**From:** Hayes, Miriam (Nicole) <mnhayes@blm.gov>  
**Sent:** Thursday, March 14, 2019 8:49 AM  
**To:** coastalplainAR; Sean Cottle  
**Subject:** Fwd: [EXTERNAL] Comment letter on DEIS for ANWR  
**Attachments:** DEIS\_CommentLetter\_JanetJorgenson\_3-2019.pdf

LETTER FROM JANET C. JORGENSEN, RETIRED U.S. FISH AND WILDLIFE SERVICE BOTANIST, FAIRBANKS, ALASKA, FOR PUBLIC COMMENT PERIOD ON DEIS FOR ARCTIC NATIONAL WILDLIFE REFUGE, MARCH 2019

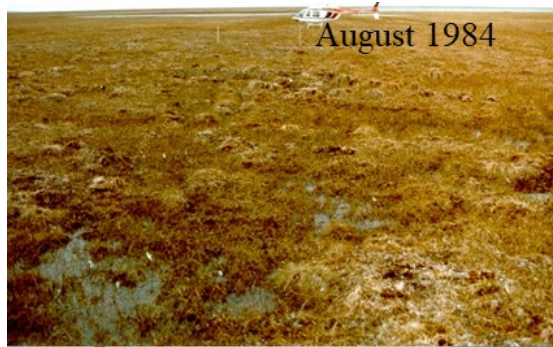
Seismic exploration in the 1002 Area in 1984 and 1985 caused more damage than anticipated and the damage persists to the present, 34 years later. The vegetation type with the most lasting damage was Moist Sedge-Dryas Tundra (moist non-tussock tundra), which covers 13% of the 1002 Area. Figure 1 show examples of trails on that vegetation type.
